ENGINE - FUEL AND CONTROL - CDX MODIFIER ADJUSTMENT FOR DELIVERED ENGINES - CATEGORY
CODE 8 - MOD.ENG-72-0218

V2500-ENG-72-0218

Location of the Data Entry Plug Assembly
Fig.1

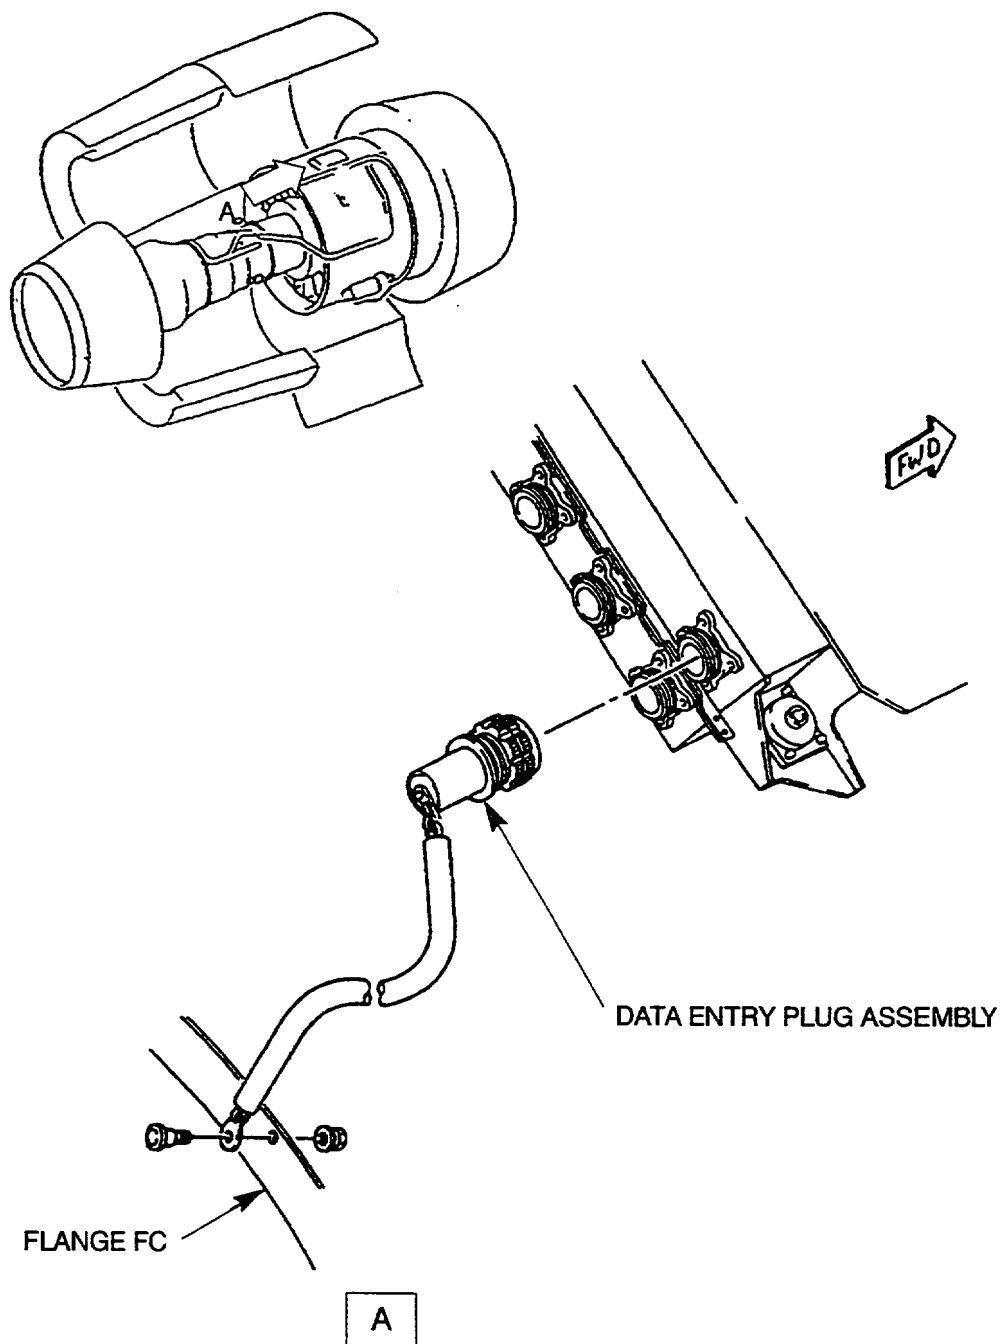
- (1) Remove the Data Entry Plug Assembly by the procedure given in Reference (2), Chapter/Section 73-21-35 Removal/Installation. See Figure 1.

- (1) Disassemble the Data Entry Plug Assembly as necessary to do the specified change to the EPR modifier.
 - (a) Use the procedure given in Reference (3), Chapter/Section 71-00-00, Testing-11.
- (2) Install the applicable jumper wires to do the change to EPR Modifier as specified in Table 1.
 - (a) Use the procedure given in Reference (3), Chapter/Section 71-00-00, Testing-11.

- (3) Make a mark on the backshell of the Data Entry Plug Assembly to show the new EPR Modifier by the procedure given in Reference (3), Chapter/Section 71-00-00, Testing-11.

Location of the Engine Identification Plate
Fig.2

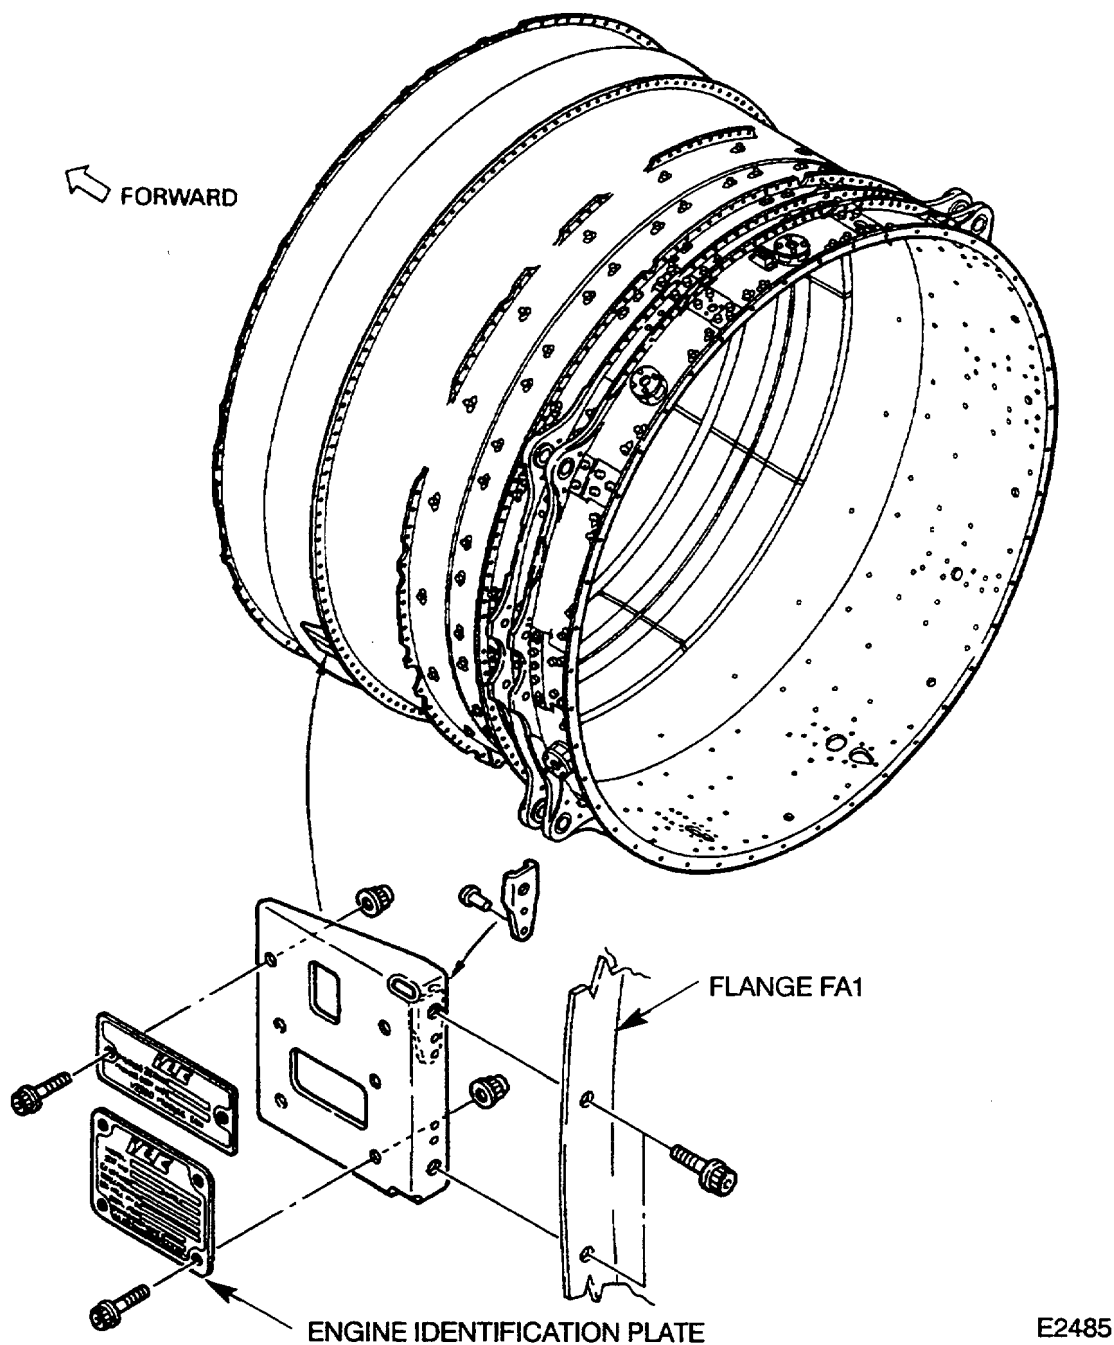
- (1) Install the Data Entry Plug Assembly by the procedure given in Reference (2), Chapter/Section 73-21-35 Removal/Installation.
- (2) Make a mark on the Engine Identification Plate to show the new EPR Modifier by the procedure given in Reference (2), Chapter/Section 73-21-35 Removal/Installation. See Figure 2.
